SBD Product Update - Change Notification

As part of HepcoMotion's process of continuous product development the SBD20-80 has had a number of internal components updated which have effect on the system lubrication positions, this document is intended to detail these changes.

SBD20-80 Standard Carriage

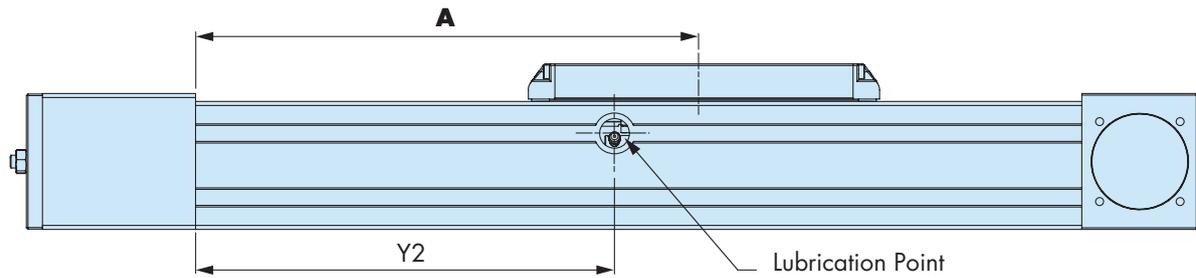
External dimensions of this unit have not changed however the position of the centre of the carriage relative to the lubrication port has altered. See table below for details.

Unit type	A	Y2
SBD 20-80 / SBD 20-80 C1	312	260

SBD20-80-B2 Long Carriage

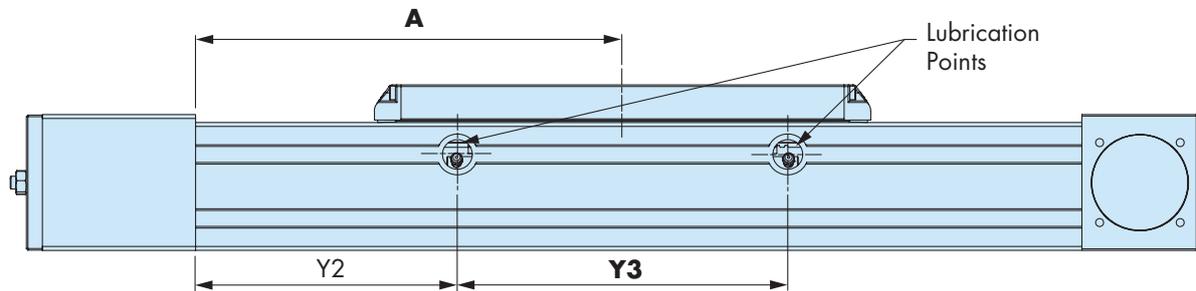
The dimensions for the position of the two lubrication ports Y2 and Y3 has been altered, See table below for details.

Unit type	A	Y2	Y3
SBD 20-80 B2 / SBD 20-80 C1 B2	258.5	162.5	192.5
